ADDENDUM 1

DATE: 01/30/18
PROJECT: UCT Expansion Interior Buildout
RFP NO: RFP 744-R1805 – UCT Expansion Interior Buildout
OWNER: The University of Texas Health Science Center at Houston
TO: Prospective Proposers

PROJECT NO: 1015236.03
 AR106
 Copyright © 2017 WHR Architects, Inc.

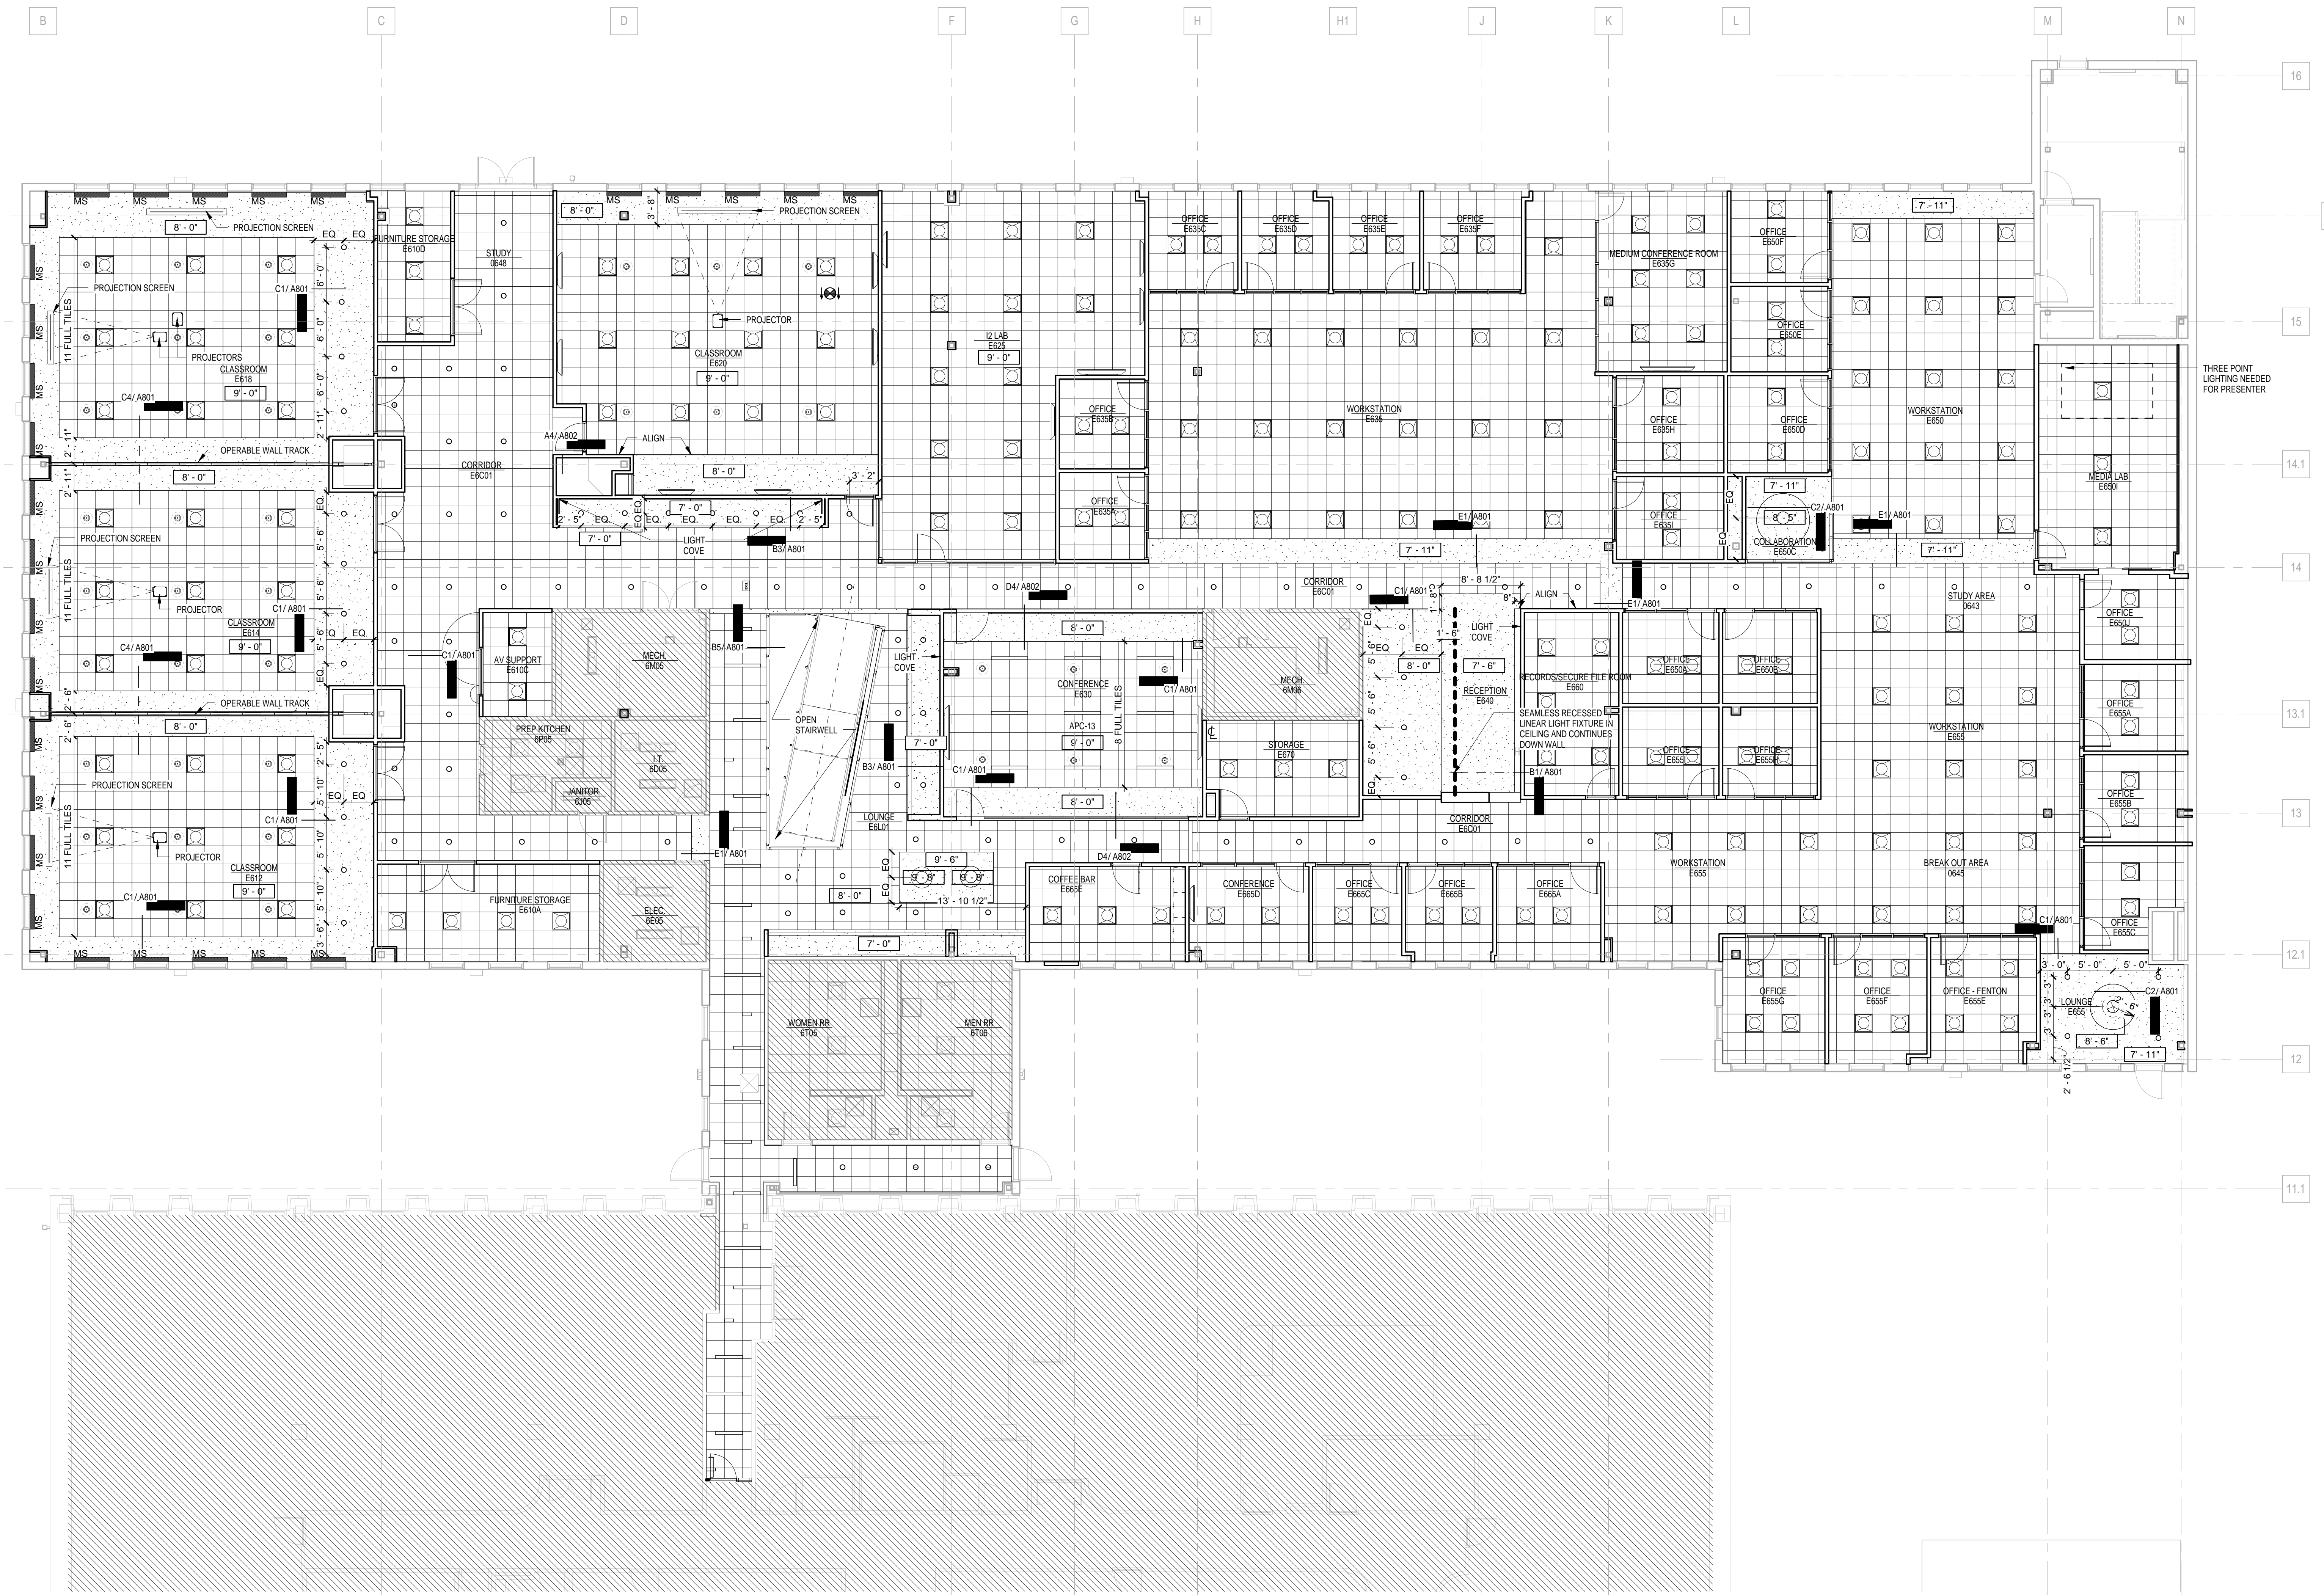
28. Sheet AR106 – Reception E640 shows a Light Cove at the plan east wall of the Reception. There is no light fixture shown in the location on the Lighting Plan (EL106). Please clarify.

Drawing provided in Addendum 1 documents.
